北部都會區——新田及牛潭尾新發展區

街道、行人及單車網絡發展跟進建議

Northern Metropolis — San Tin and Ngau Tam Mei New Development Areas
Follow-up Suggestions on the Development of Street, Pedestrian and Cycling Networks

街道變革 及 九龍綠色通道
2026 年 1 月

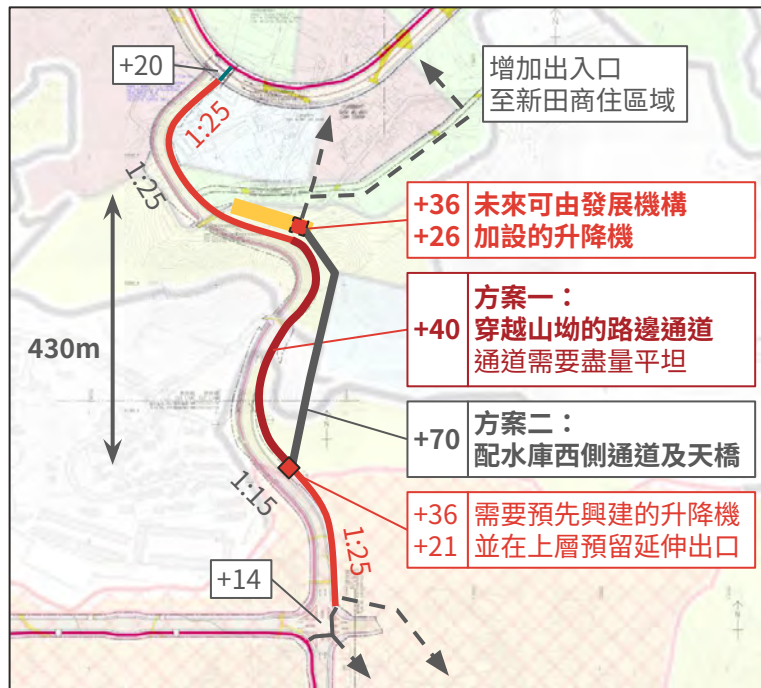
- 我們建議調動連接路的空間分配，將行人路及單車徑設於道路東側，而非圖則所示的西側。考慮因素如下：
- 新田方面，連接路（連同行人路及單車徑）在發展區邊界外順應地勢繞行，與高密度住宅用地直線距離 100 米內，有潛質加設捷徑。將通道設於道路東側，可預留連接點，容許未來任何工程項目倡議人或發展機構研究及加建升降機，以吸納更多使用者。行人及單車亦毋須橫過主要道路即可到達升降機入口，方便而且安全。
- 牛潭尾方面，道路東側毗連大學城最大地塊（被道路分割後）。將通道及升降機設於東側，相信能吸納更多使用者，讓更多人毋須橫過道路來往大學城和連接通道。
- 此舉可為後頁更多方案締造條件，局方可考慮採用。

方案三：行人及單車隧道

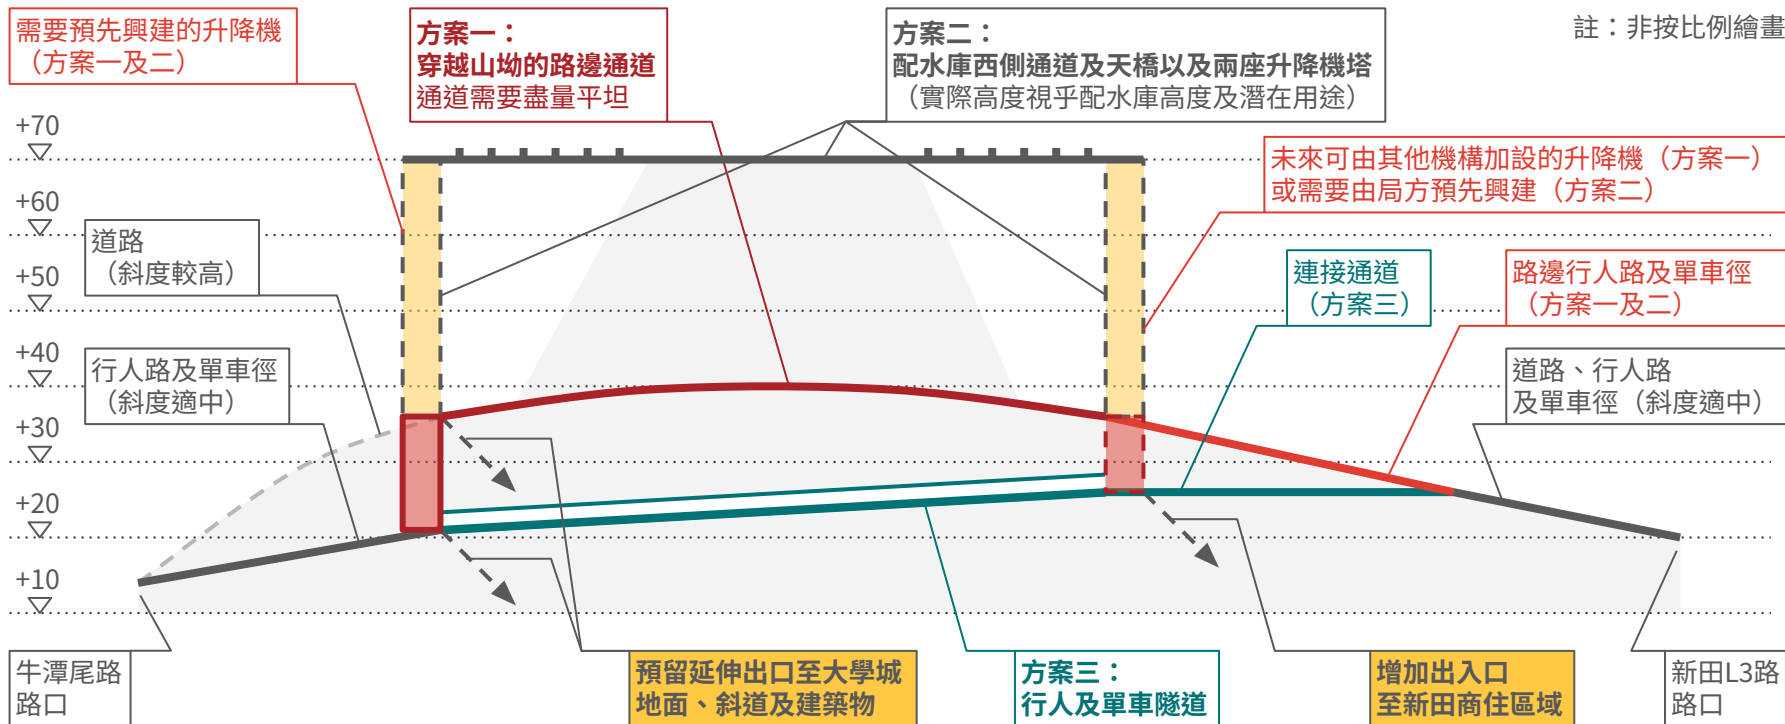
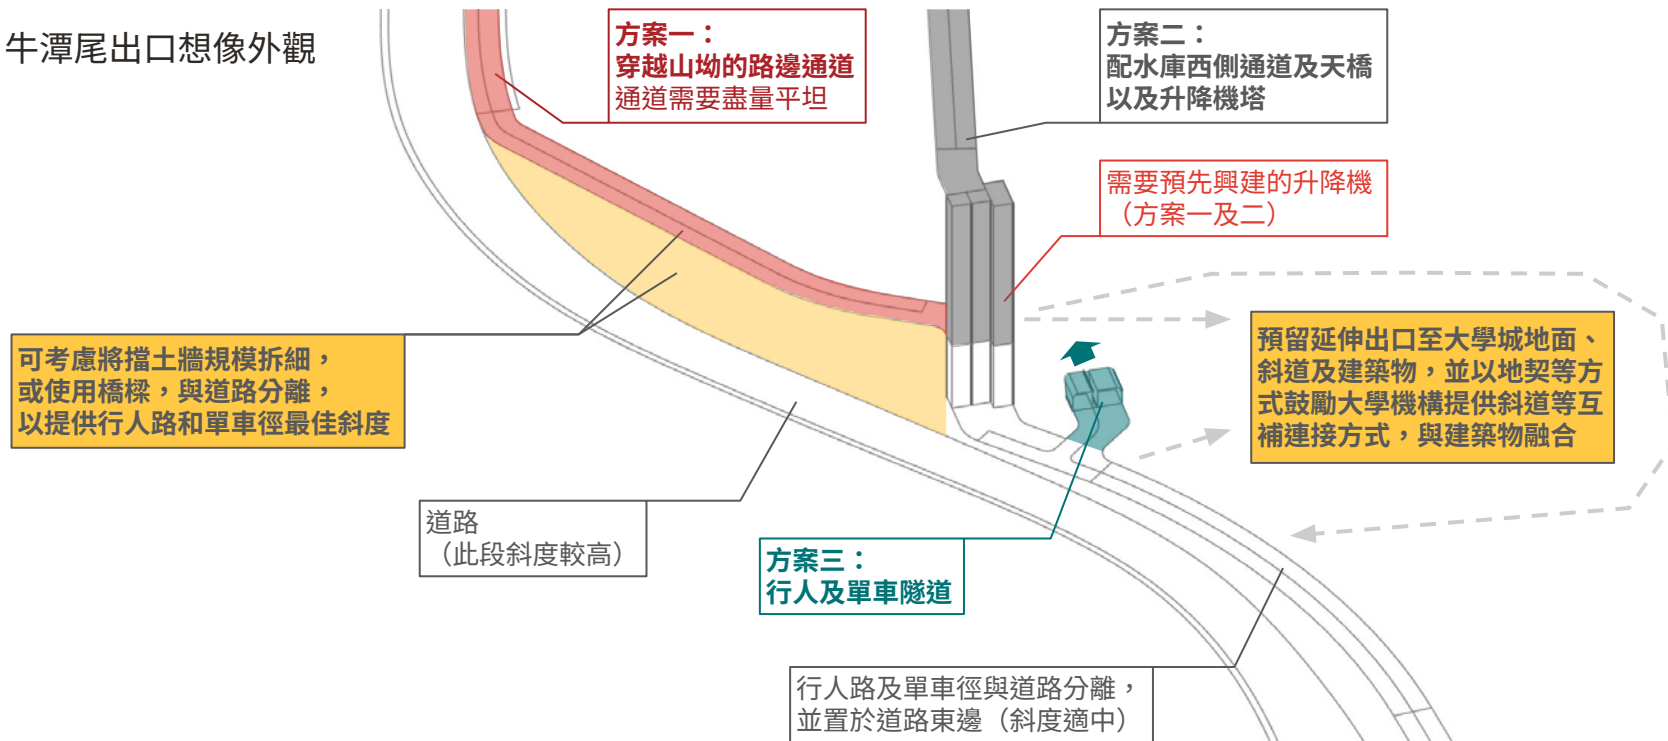
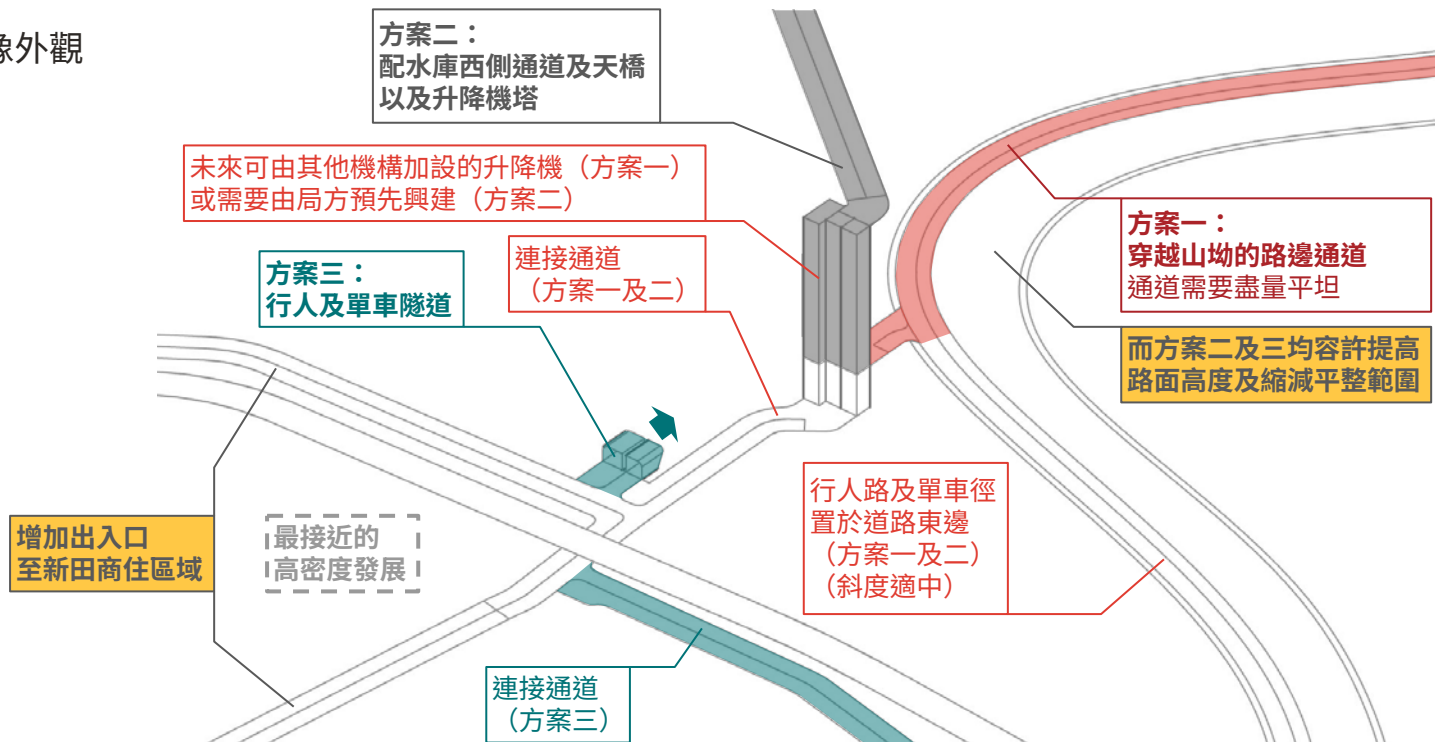
- 局方可考慮善用牛潭尾大學城與新田最接近的住宅用地之間的直線距離，設置長約 430 米的行人及單車隧道，提供高質素的無障礙設施。
- 此方案可減少行人路的闊度和降低規格、取代穿越山坳的單車徑，可進一步縮減道路土地平整的範圍及解除馬路斜度局限，更毋須設置升降機。
- 相信隧道需要配備合適的通風、消防及管理系統。可參考尖沙咀麼地道行人隧道及澳門松山行人隧道等例子。亦可研究以隔火牆分隔行人及單車隧道，互相以防火門及隔火間連接，模仿公路隧道的跨管道逃生方式。

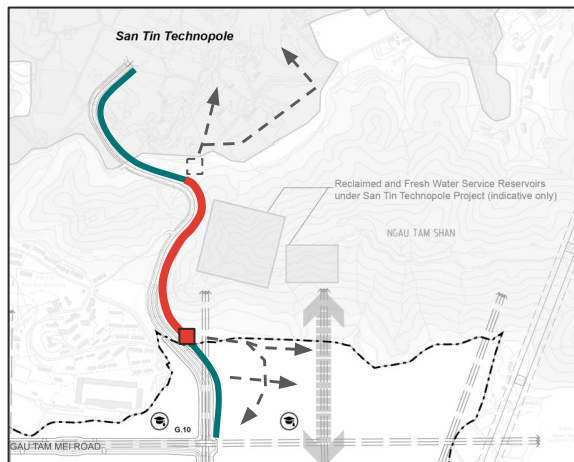
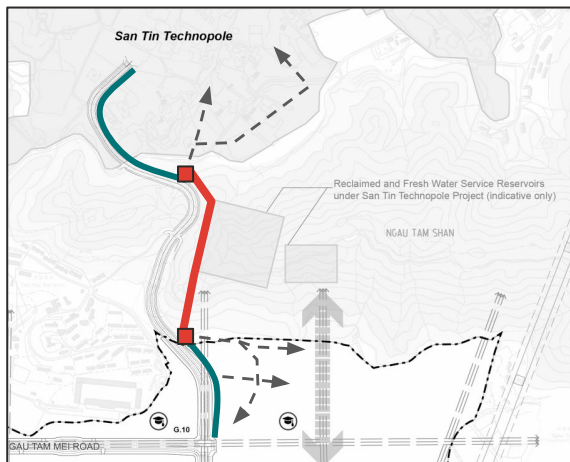
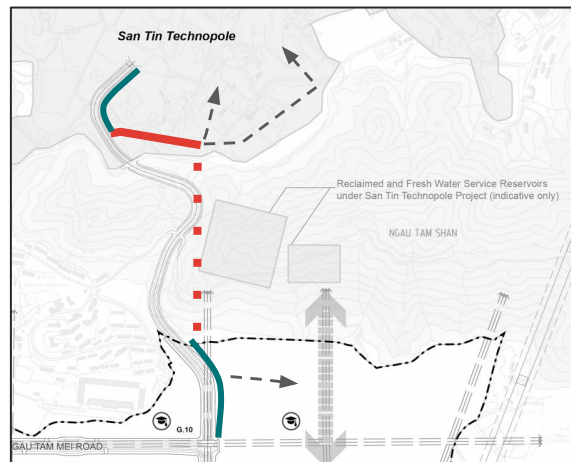
- 三個方案均各有優劣，成本及效益亦各有不同，更毋須全由局方安排。只要將行人路及單車通道設置在道路東邊，將提供最大彈性和誘因，給予將來的大學及其他機構安排加強行人及單車連接。

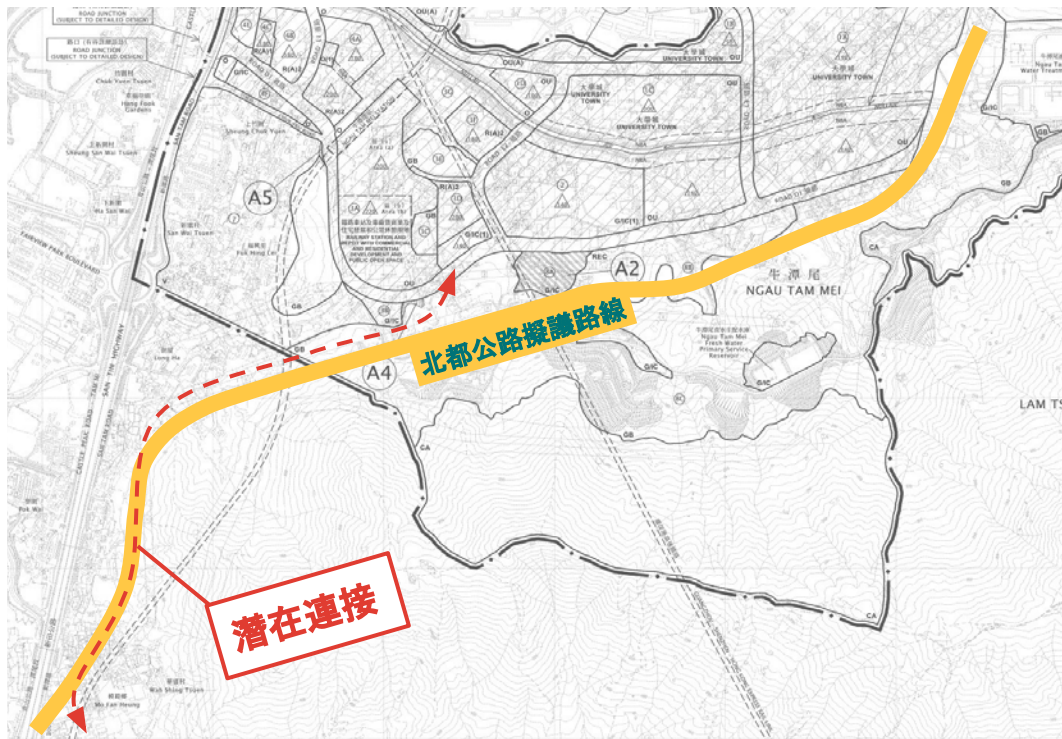
- 新潭路主要為雙線雙程道路，交通愈趨繁忙，對安全騎單車技術挑戰甚大。雖然有私人發展商計劃延伸新界單車徑網絡至沙埔發展區（即北環綫凹頭站），但來往牛潭尾的「主幹單車徑」路線依然迂迴。
- 若能借助北都公路工程，為牛潭尾與沙埔發展區之間附設適合騎單車的連接通道，將為單車、行人，乃至鄉村日常交通提供更多選擇，適合騎單車的路線可由4公里減至2公里，更保障北環綫及主要公路之外的交通韌性。

大埔大美督路
現況

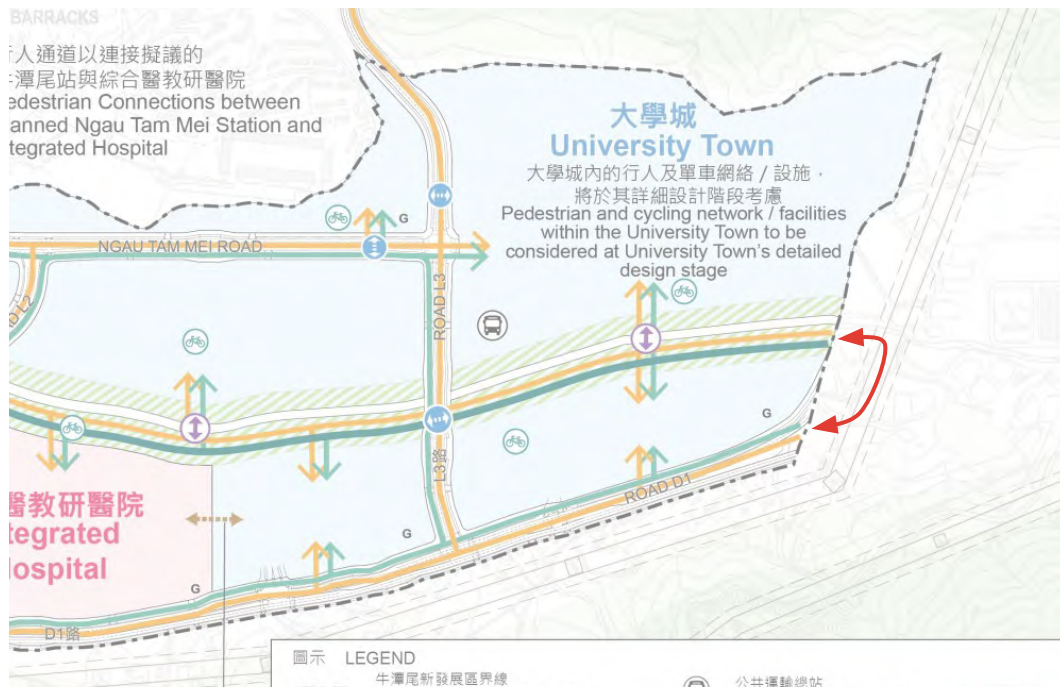
- 如情況許可，讓行人及單車優先使用過路處，更能鼓勵活躍出行效果。

只需改善過路處，即可容許騎單車優先過馬路
